**Dryden Planning Board  
August 24, 2017**

**Public Hearing to consider the preliminary plat submitted by SUN8 PDC LLC (c/o Distributed Sun LLC) acting on behalf of owner Scott Pinney. Applicant wishes to subdivide a 158.145 acre parcel, Tax Parcel 38.-1-3.1 located at 2150 Dryden Road. Five lots would be created for the purpose of siting large-scale solar energy systems.**

**PROPOSED SUBDIVISION PLAN OPTION 3**  
 2150 DRYDEN ROAD BEING PART OF MILITARY LOTS 36, 37 AND 47 IN THE TOWN OF DRYDEN COUNTY OF TOMPKINS STATE OF NEW YORK

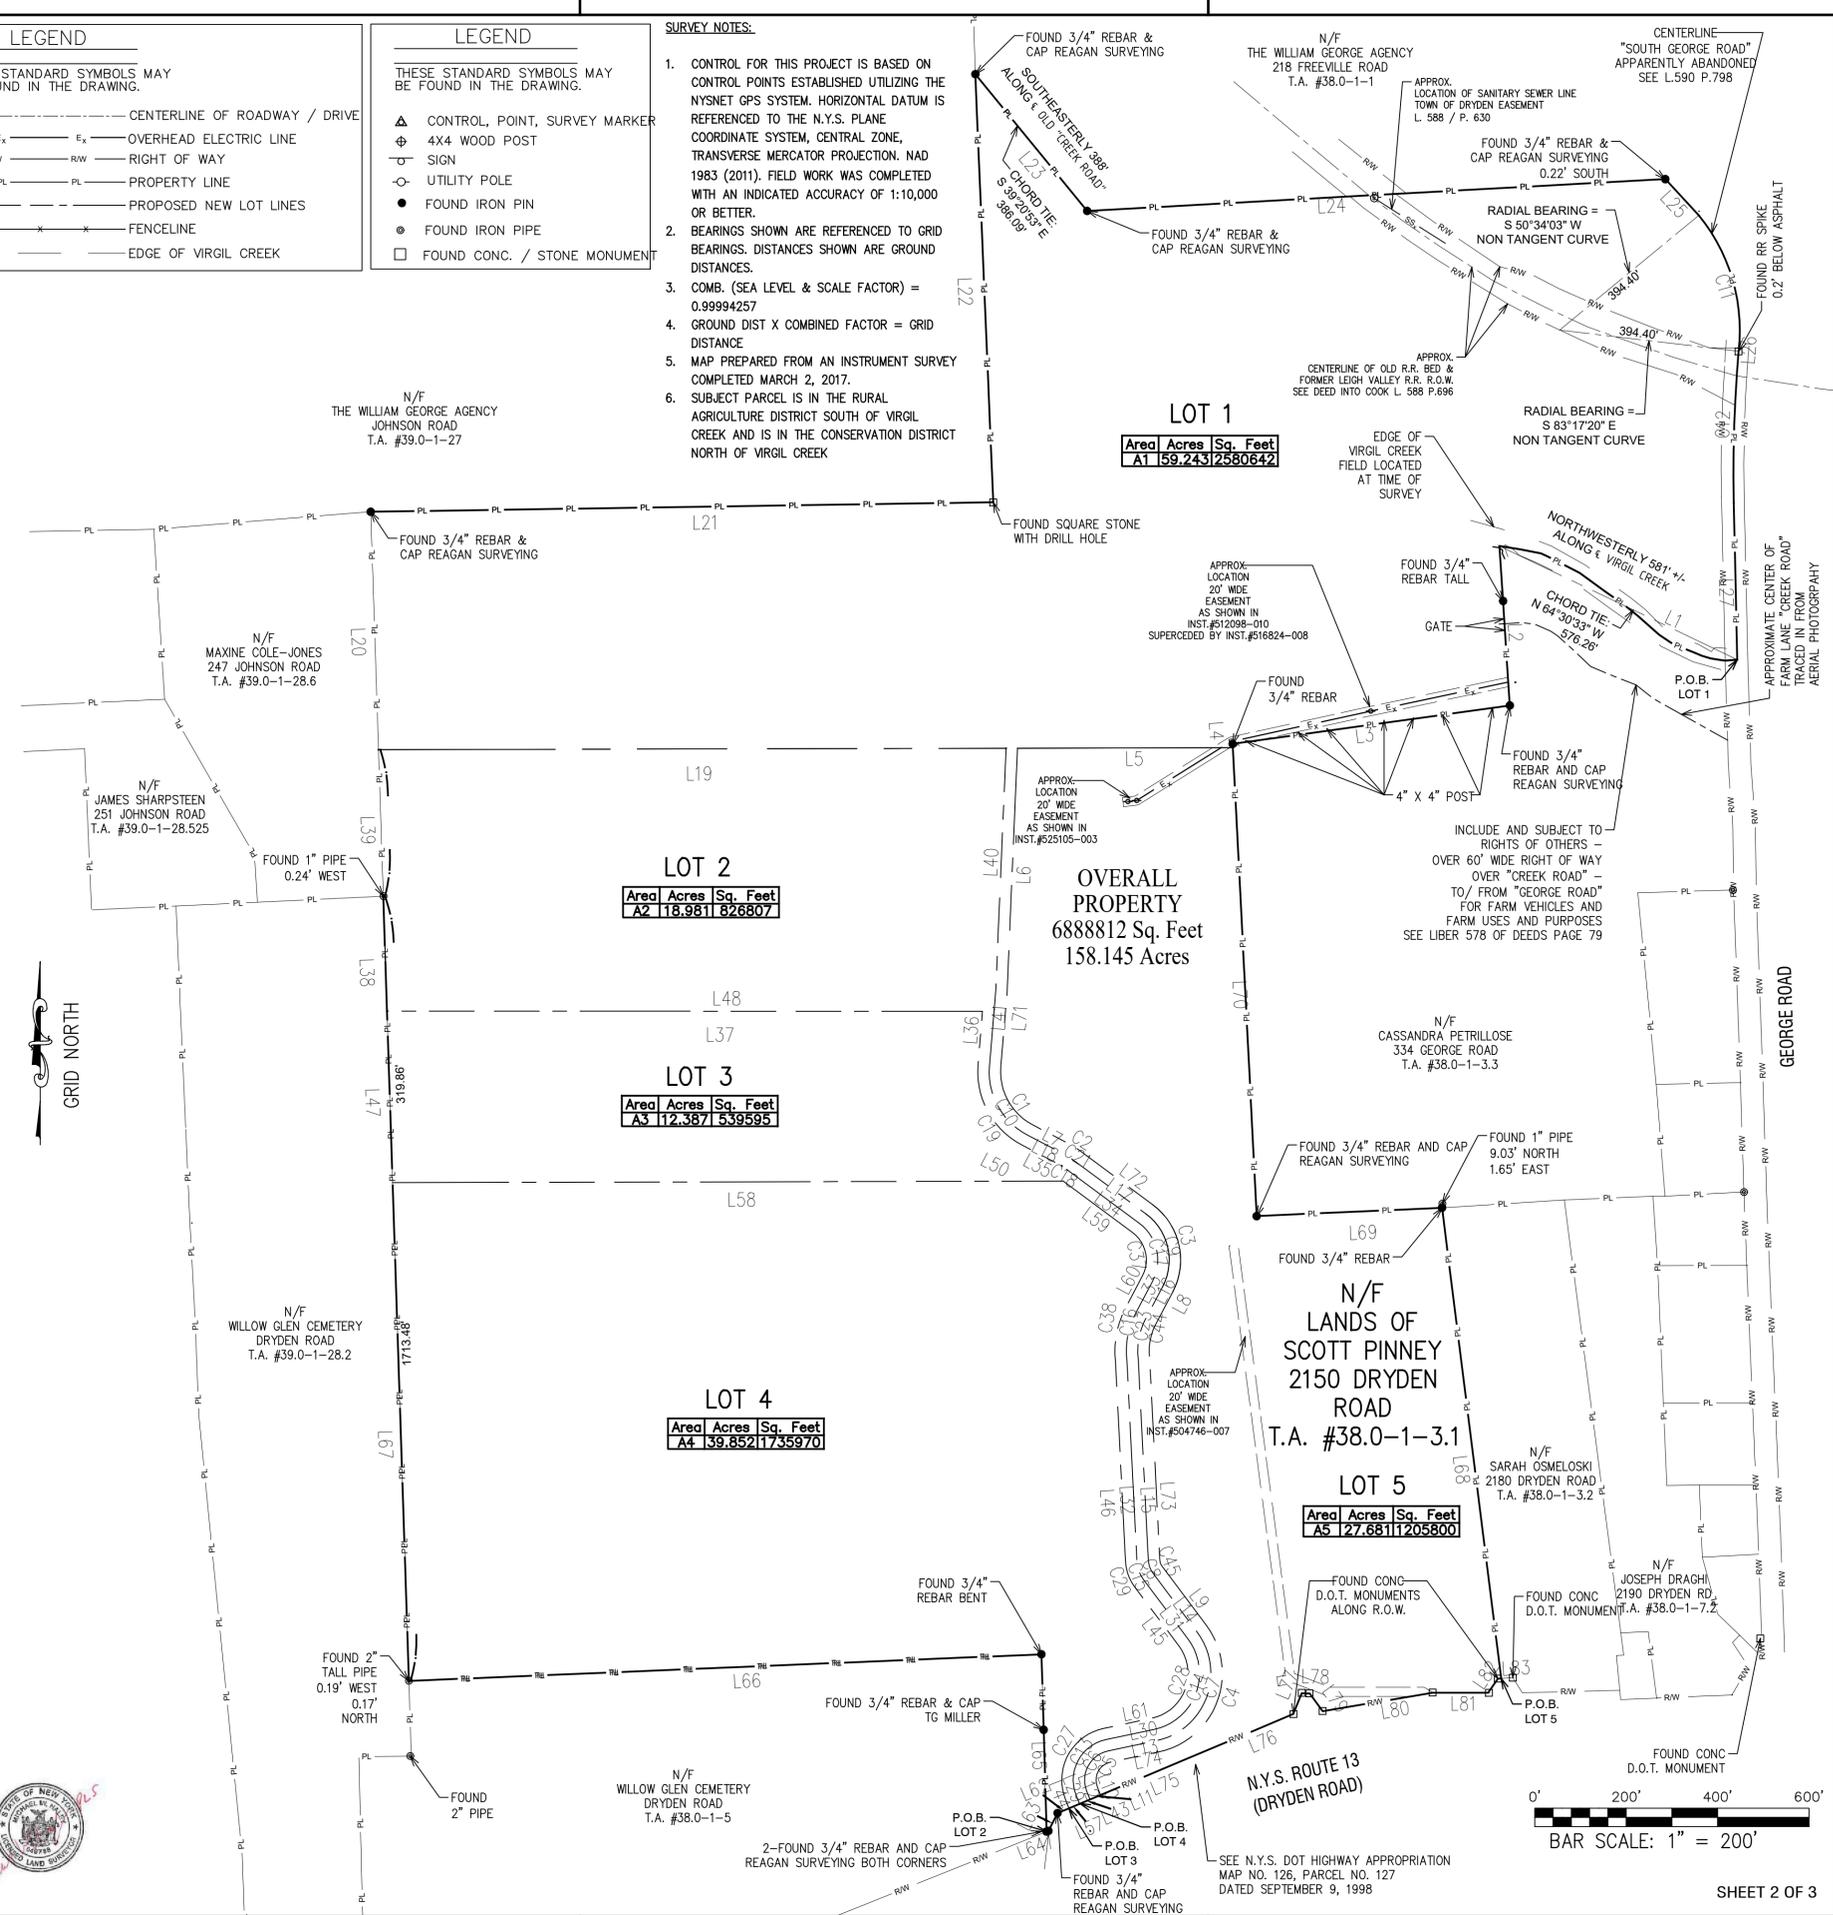
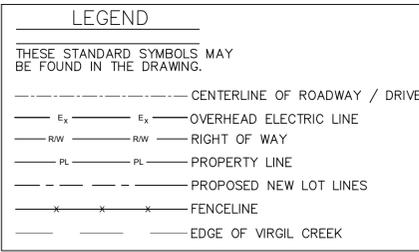
The other thing, I am looking at this flag lot arrangement and lot two starts at 95 feet wide and goes down to 50 feet wide by the time it gets to the road. Lot three has a 25 foot piece of property that goes around and comes out at the road at 25 feet. Lot four has a 25 foot thing. I don't understand how these widths work but there seems to be an inconsistency there. Lot one, you can't access from George Road because the frontage is on the other side of the creek. I am looking at the lines of the subdivision and how it applies to the zoning law.

T. Hatfield pointed out that after the sketch plan, the board received from the developer, two maps both identified as V2. The Board and the public had 21 days to review the maps but tonight the Board was told that they can only consider one of the two maps. The one that we cannot consider more closely matches what we asked for at the sketch plan.

He further noted that at the sketch plan, the Board concluded that flag lots are not necessary and the common driveway can provide frontage. The flag lots act like a reserve strip which is prohibited in the zoning law. He reminded the Board that the subdivision is not just for this one project.

C. Anderson said that he was under the impression that the Board did not want flag lots; that the Board wanted it all on a common driveway which is what the developer shows on the other plat. He believes the flag lots work as reserve strips. He asked for a legal opinion on that issue. The property lines are drawn right up to the other driveway, which was one of the conditions the Board asked for. On this drawing we do not have access points to the facilities. The other drawing had driveways off the common driveway accessing each lot.

T. Hatfield said that he wants it drawn out. When we left the sketch plan review it was with the understanding that you would use the common driveway for frontage which is not what was submitted. He is willing to meet again to approve a clean plan. It is only fair to the Board and the public. The plan has changed many times but this is a subdivision. He again referenced the other map that was submitted with the one under review.

4. the applicant will delineate the width of the easement to Lot 1 from George Road; and
5. the applicant will redraw the flag lots to the specifications presented on the "Proposed Subdivision Plan Option 3" plat by Mr. Haley dated 8/22/2017.
